Service Note		
Product	Description:	Service note no.
Finalizer 96K	Upgrade of Finalizer 96K to do Up/Down sampling	720 10 02 07

This note only concerns units with serial no. lower than 1214250.
The upgrade should only be carried out by qualified technicians.

Fig. 2: Location of R291 and PLL circuit board

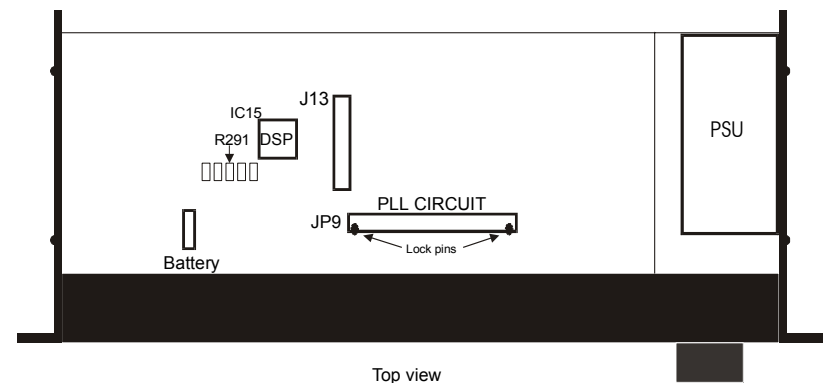
1. Use a PCMCIA card to make a copy of the user presets.
2. Turn Off Power and Disconnect Power Cord.
3. Remove the top lid by loosening five screws, see fig. 1.
4. Remove the old PLL board (P12906-3) by pressing out the lock pins, one in each end, see fig. 2.
5. Install the new PLL board (P12906-5), - check the lock pins locks the board.
6. Mount a 0 ohm resistor at R291, see fig 2.
7. Mount the top lid.
8. Load in application software version 3.5 (or higher)
9. If necessary; load in the user preset. Presets are compatible.
